REPLACEMENT SYSTEM VARIANCE REQUEST

SUBSURFACE WASTEWATER DISPOSAL SYSTEM APPLICATION
TOGUS POND, ROUTE 105, AUGUSTA, MAINE
Property Of
NATIONS CREDIT FINANCIAL SERVICES
July 1993

REPLACEMENT SYSTEM VARIANCE REQUEST
CONDITIONAL

SUBSURFACE WASTEWATER DISPOSAL PLAN

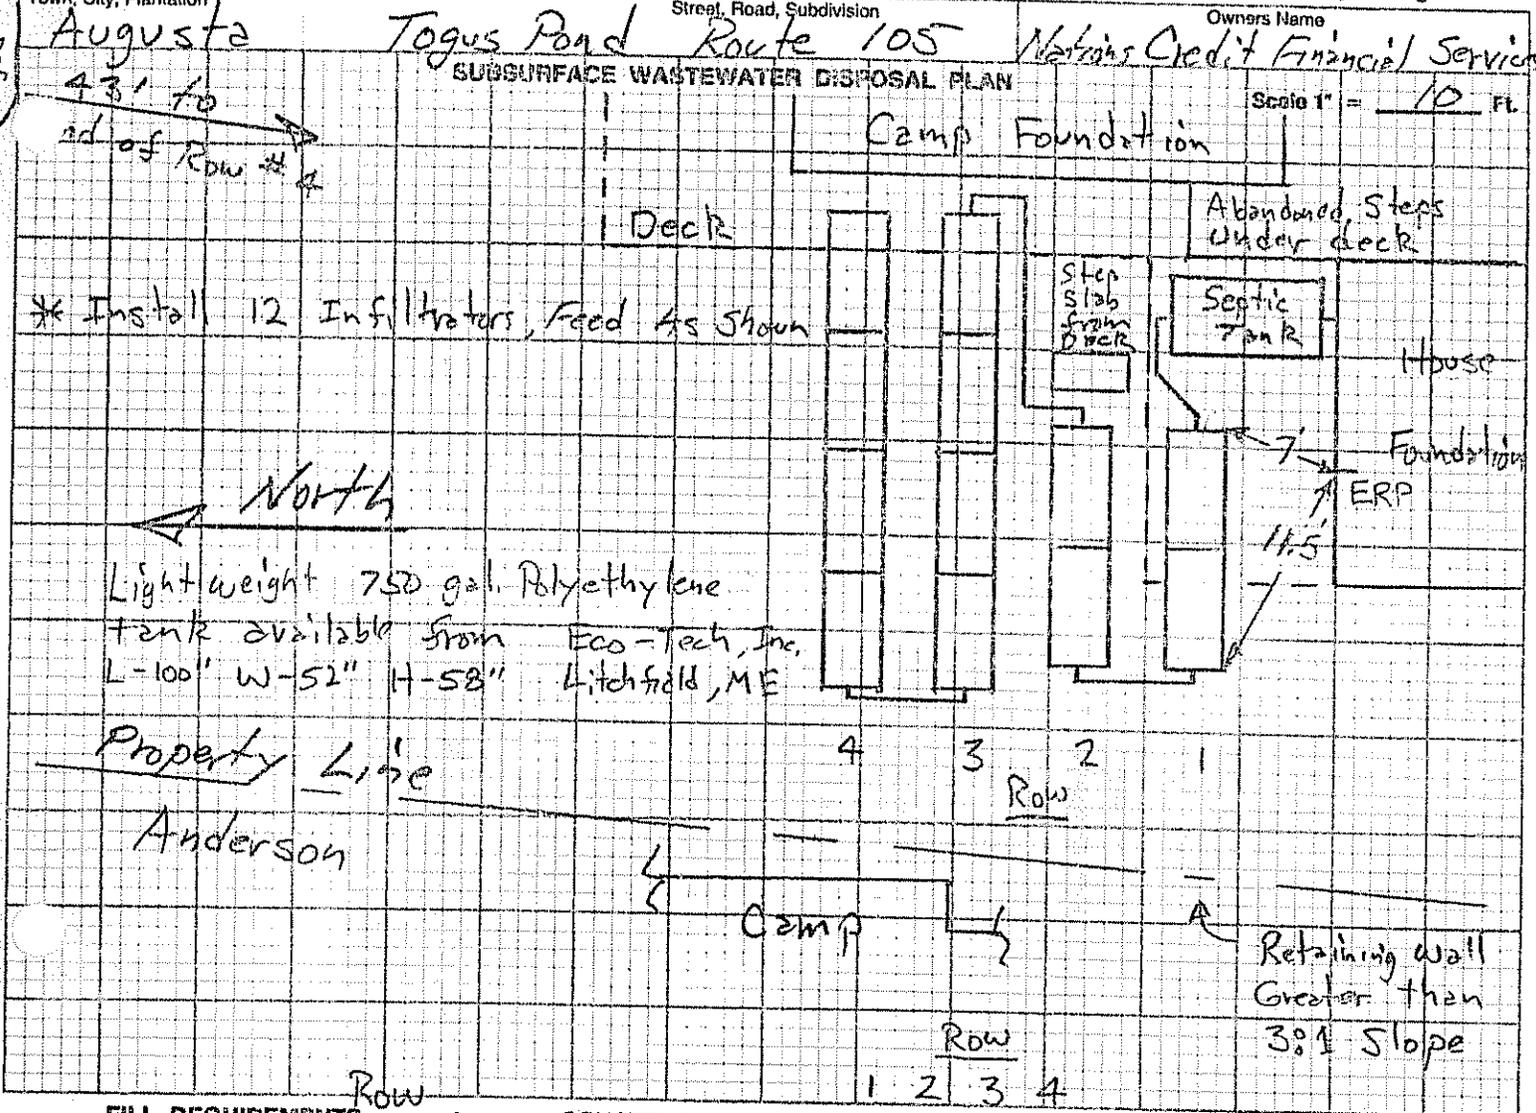
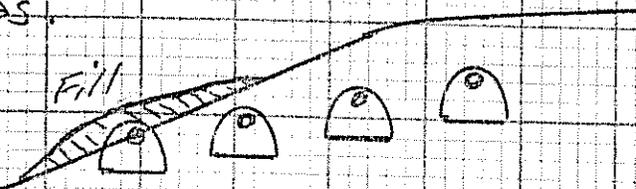
There is little room to maneuver on this site when a subsurface obstacle is encountered during construction. Because of this the variance request is asking for more than is laid out on site. Rows #1 and #2 are ten feet from the retaining wall, but the request is for eight feet. Rows #3 and #4 are nine feet and seven feet respectively from the Anderson camp and property line but the request is for seven feet and five feet respectively. The east end of row #4 is 43' from Togus Pond and the variance request is for 40'.

This system can be installed to operate by gravity if the plumbing in both the house and camp is raised. The rows of infiltrators are set low enough to have everything under ground. The replacement septic tank, however, is larger than the existing tank and there may be problems getting it totally under ground. If part of the tank remains above ground freeze protection should be provided. The rows of infiltrators can be raised if necessary and this would require more fill. For example if rows #1 and #2 were raised one foot, six inches of additional fill would be required over the existing ground.

The Division approves the variance with the following conditions:

1. The existing house is approved for the usage of the proposed 147 gallon per day system designed by Charles King, Site Evaluator.
2. The existing camp is not approved to utilize the 147 gallon per day system. The camp will require a separate holding tank application stating the one bedroom camp will be used only seasonally.
3. A water meter and low volume fixtures shall be installed.
